ADDENDUM NO. 1

VILLAGE OF NEW MADISON
Darke County, Ohio
Water Plant Electrical Power & Controls Upgrade
October 13, 2015

Re: Village of New Madison, Darke County, Ohio
Water Plant Electrical Power & Controls Upgrade

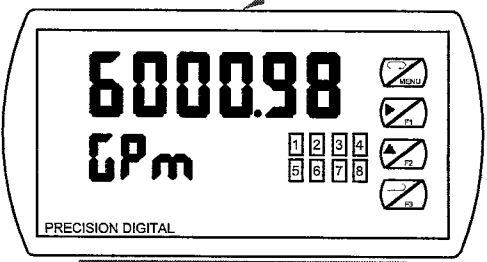
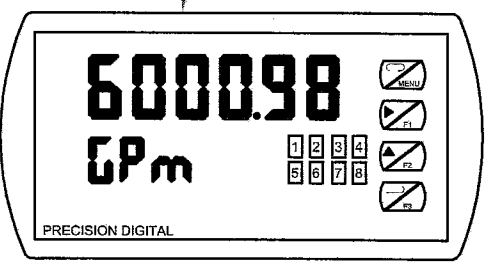
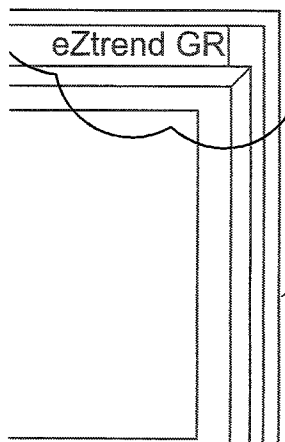
- A. The two Precision Digital meters located in the MCP which receive identical signals from Panel CP-1 shall be the same model of meters. See Exhibit #1 attached hereto.

PRECISION DIGITAL
THESE TWO METER ARE TO MATCH THE
TWO WITHIN PANEL CP-1, PD6200-6R7
OR 6300-6R7
120VAC

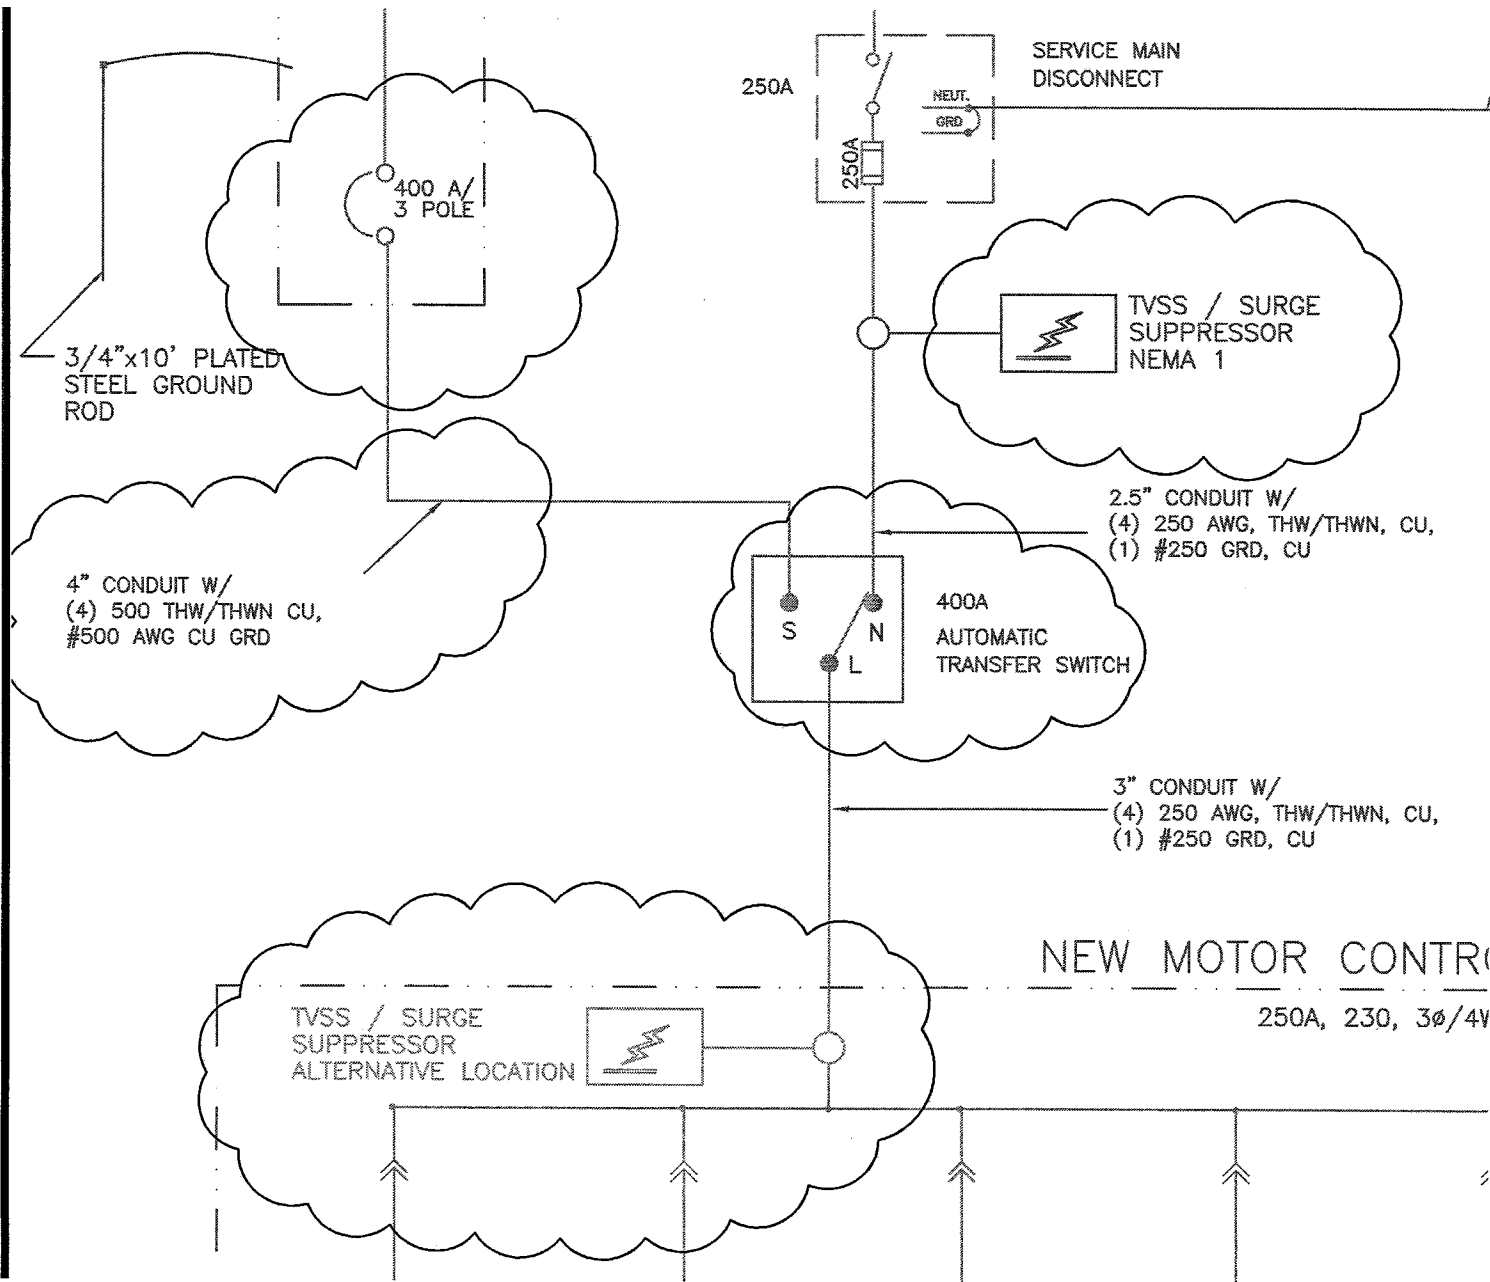
- A. See Exhibit #2 attached hereto for the following clarifications for the single line schematic:

- a) The main breaker on the generator and Automatic Transfer Switch has been upsized to 400 amp.
- b) The conduit and wire from the generator to the Automatic Transfer switch has been changed to (4) 500 THE/THWN CU and 4” conduit.
- c) The “Lightening Surge Suppressor” has been renamed “TVSS / Surge Suppressor”
- d) An alternative location for the TVSS has been added.
